RE: Amended Concept Proposal – Harbourside Shopping Centre Redevelopment (SSD-7874)

*Figure 1: Highlights excessively large and bulky Podium*

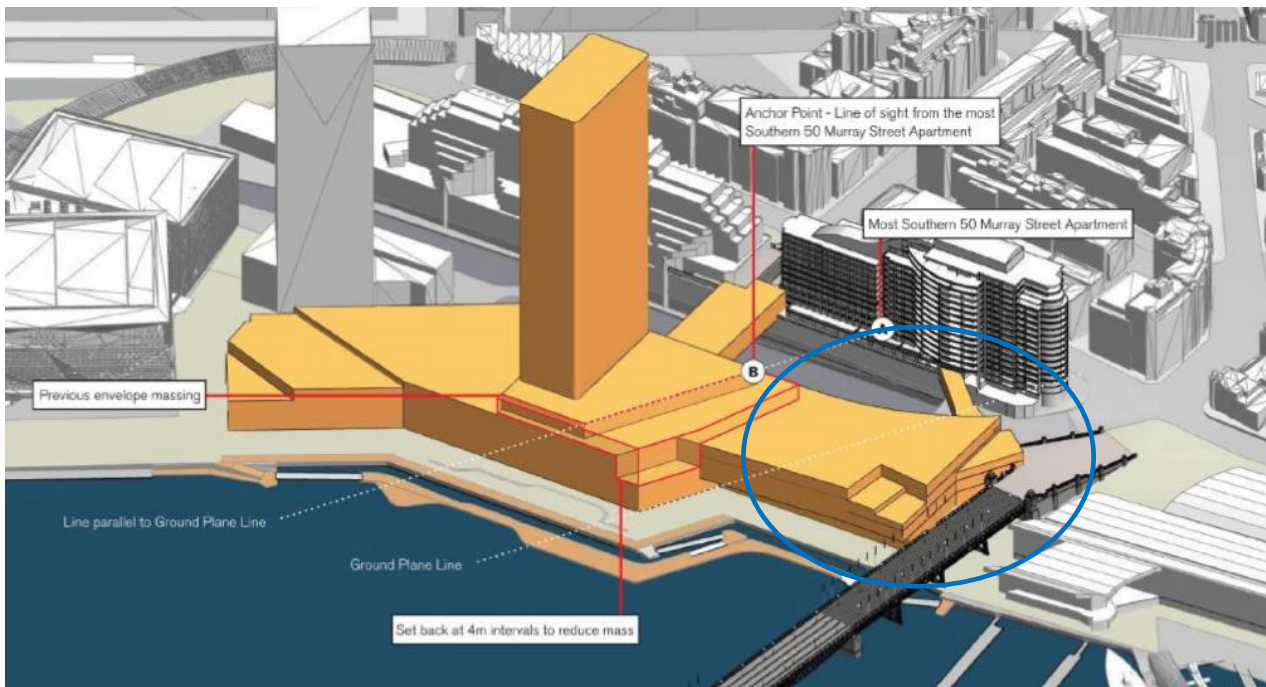
***PRIMARY OBJECTION IS THE HUGE BULK AND EXCESSIVE HEIGHT OF THE “PODIUM”, PARTICULARLY AT IT’S NORTHERN SECTION.***

The amended proposal SSD-7874 does feature a smaller footprint and better location of the main Residential/Commercial Tower, HOWEVER the PODIUM is **excessively bulky** and extends far too close to the Pyrmont Bridge, resulting in its massive height and bulk destroying the Darling Harbour Precinct.

- a. Sunlight: The amended design proposal does nothing to improve sunlight along the main Western Promenade of Darling Harbour that the development purports to support. The entire West Promenade will be without sunlight from 2pm onwards.  
Why? The PODIUM is too tall. The proposal represents an extreme overdevelopment, seeking to change an existing two storey structure into a **five** storey structure, PLUS Bulking it up enormously (refer to **Figure 1**).
- b. Dominance: The PODIUM will dominate our Historic Pyrmont Bridge and the whole West side of Darling Harbour. Bridges, by nature, are usually higher than adjacent structures.

The Northern end of the PODIUM should be not more than two storeys high and be slightly lower than the Bridge while also being set a good distance away from the Bridge. The entire PODIUM must be kept to a maximum of three storeys to allow sufficient sunlight to enter the Harbour and the Promenade from the North-West beyond 2pm and into the late afternoon.

*Figure 5: Devaluation of Murray Street property due to obstruction of views*

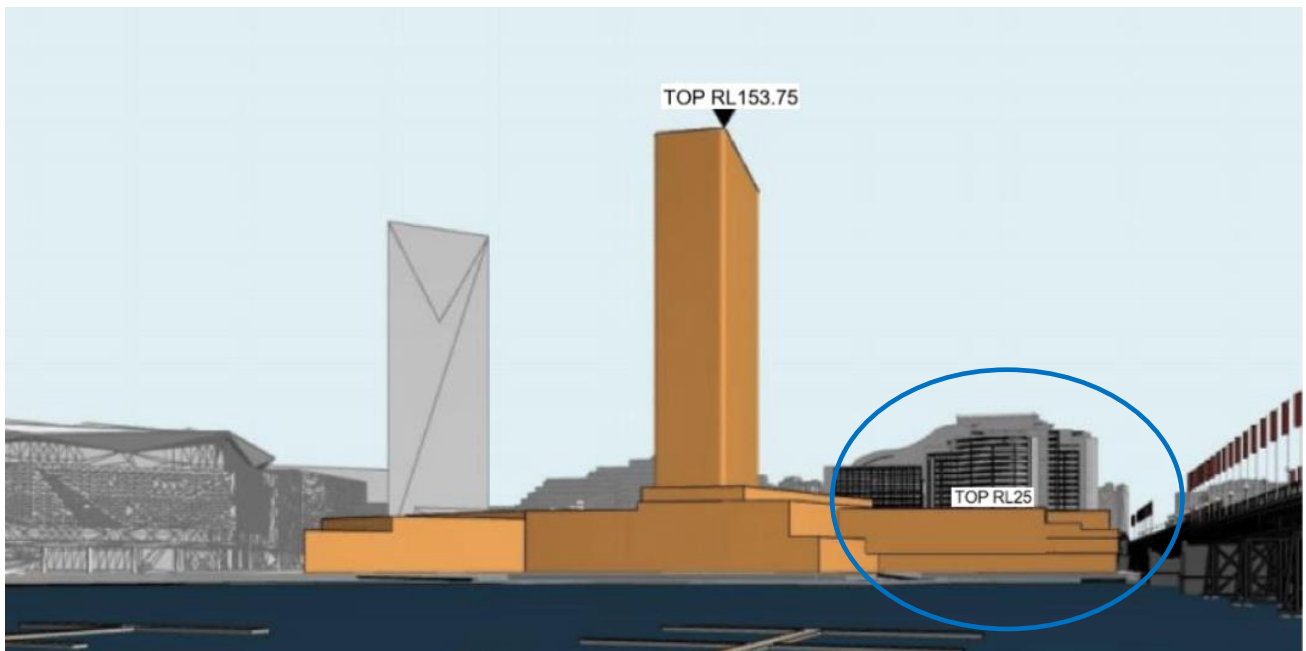
- Retail Shop space demand is on the decline.
- Commercial office buildings already overcrowd the city and there are plenty of vacancies.
- Devaluation of residential property on Murray Street is inevitable due to loss of views (refer to **Figure 5**).
- The present Harbourside Plaza Eateries are not reaching capacity.
- There is the potential of creating a ghost complex...
